# **Dewberry Response to USGS/FEMA Region 2 Review of the NY Great Lakes Area QL2 LiDAR - Orleans County Processing Project**

Produced for U.S. Geological Survey

Task Order:G14PD00043

Figure 2 – Tile 17TQJ330065. Issue seen by USGS in top image and corrected DEMs shown in bottom image.

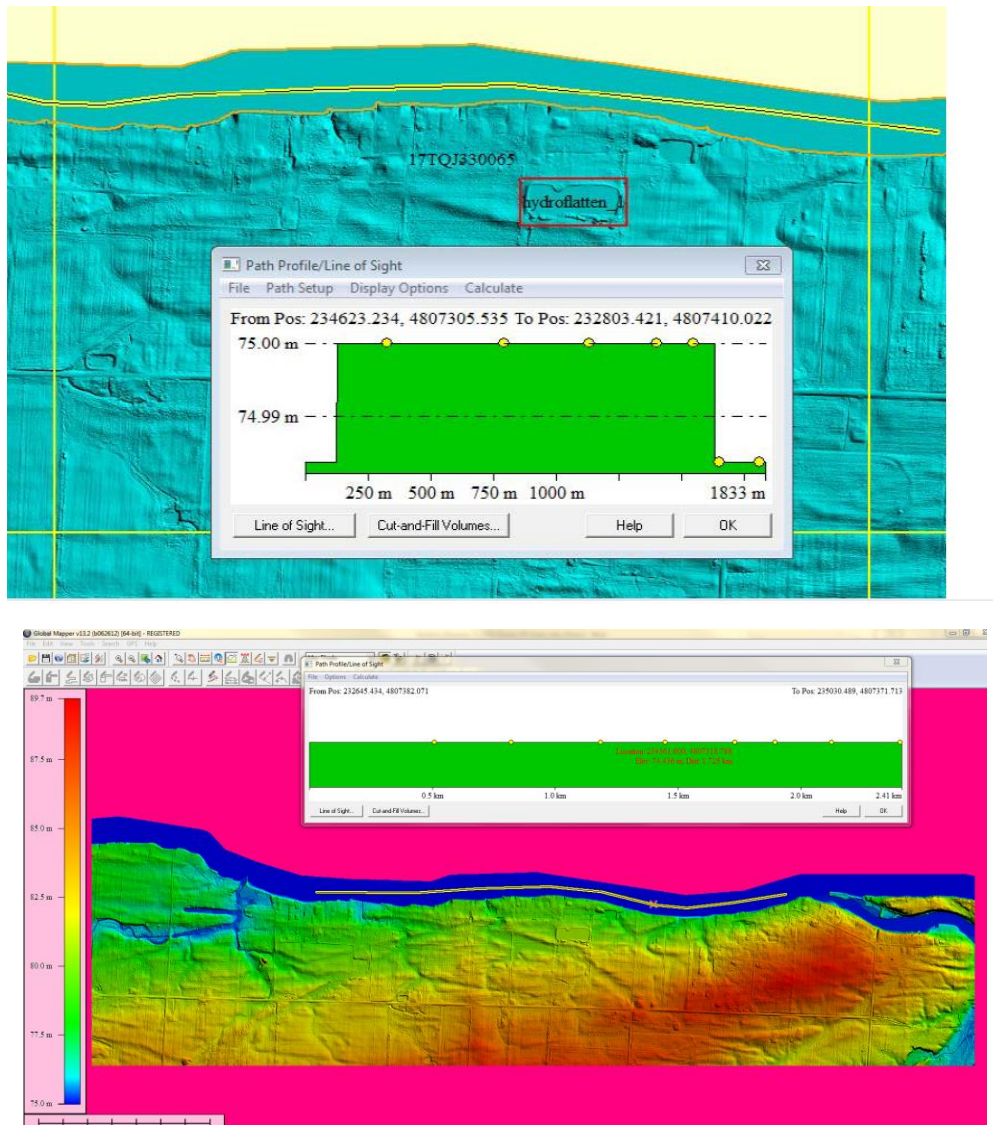
There was one location where USGS identified an area of water that was not hydro flattened uniformly with its neighboring tiles. The affected tile was reprocessed in the same manner as the neighboring tiles, correcting the issue so that the hydrographic feature is consistent across tile boundaries. Another water feature was found during review that had a small hydro flattening issue and this feature has also been fixed.

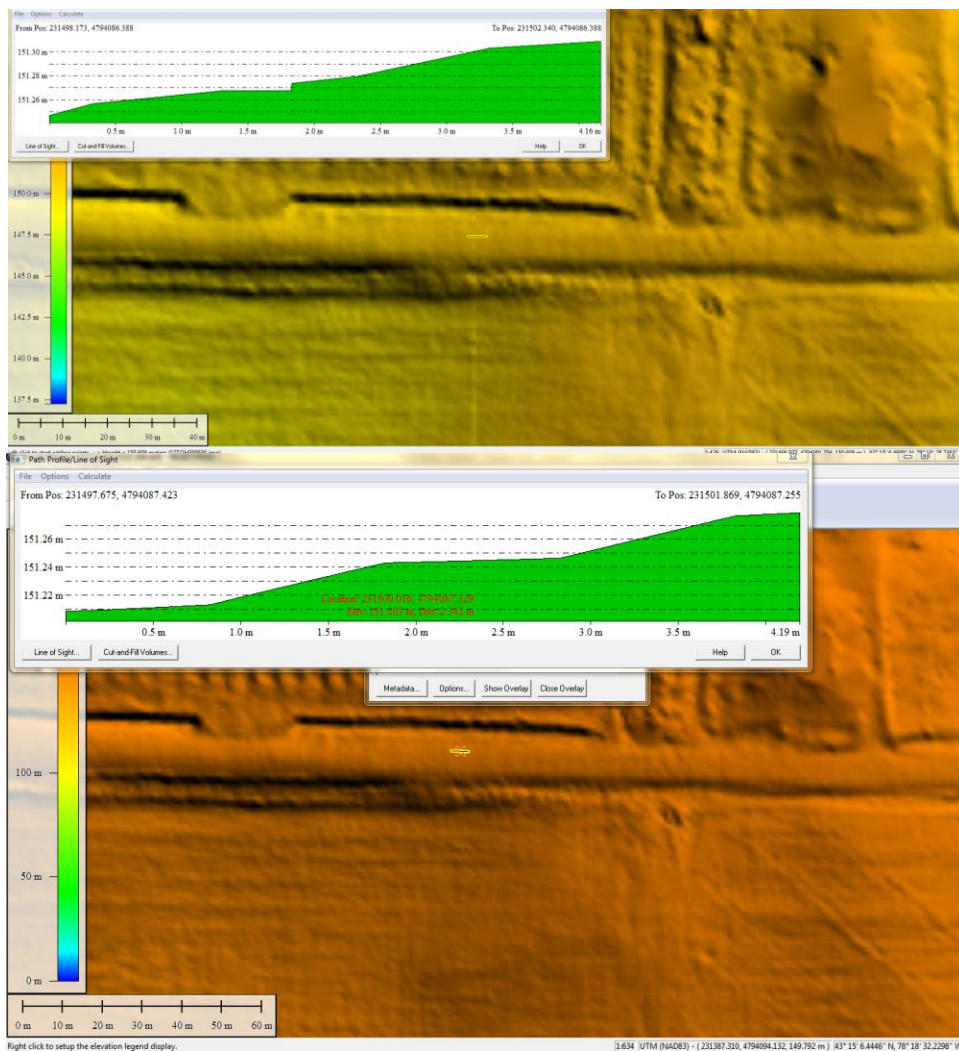
There was a general call made by USGS that the DEMs did not have proper edge matching. The edge issues identified by USGS are only visual artifacts created by Global Mapper along tile boundaries. Global Mapper creates the appearance of a small elevation shift between the tiles because of the way it renders hillshading on a tile by tile basis, creating a false ridge between the border pixels. Global Mapper usually creates this small visual artifact on all tiled data, but it is typically more apparent in flat terrain and may ‘disappear’ in sloped areas. If tiled DEMs are merged or mosaicked into a single DEM, all edge artifacts will disappear because they are not actually in the elevation dataset, but are merely a visual artifact caused by Global Mapper. The screenshots below show a comparison of two cross sections in the same location: one is with the delivered tiled data and the other is with a one merged, non-tiled raster.

Figure 4 – Tiles 17TQH300930 and 17TQH315930. The top image is the tiled data and shows the visual artifact created by Global Mapper on all tiled data. The bottom image is the merged, non-tiled raster with a cross-section in the same location showing there are no actual artifacts or ridges present in the elevation data.
